# Technical Service Bulletin

## 32 Transmission leaking

32 13 04 August 12, 2013. Supersedes Technical Service Bulletin Group 32 number 08-01 dated December 20, 2007 for reasons listed below.

Model(s)	Year	VIN Range	Vehicle-Specific Equipment
Q7	2007	000000 - 079498	4.2 L

Figure 1. Torque converter seal

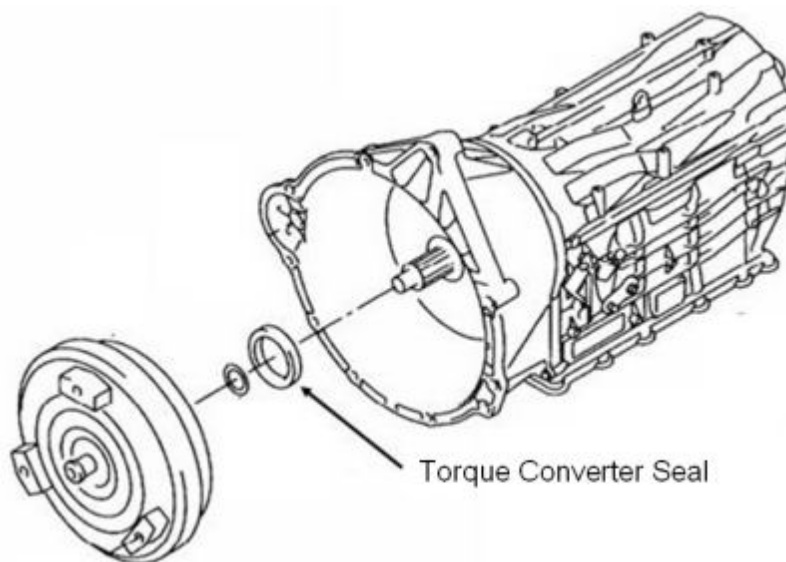
ATF is leaking from torque converter oil seal (Figure 1).

Dust/dirt intrusion into the bell housing may damage the seal.

- Improved torque converter oil seal.
- Close-out caps installed in bell housing.
- Cover installed between transmission and starter motor.

1. Replace the torque converter seal (refer to *Repair Manual Gr.32*).
2. Snap close-out caps into openings at both sides of transmission bell housing.
3. Install starter motor cover during installation of the transmission.
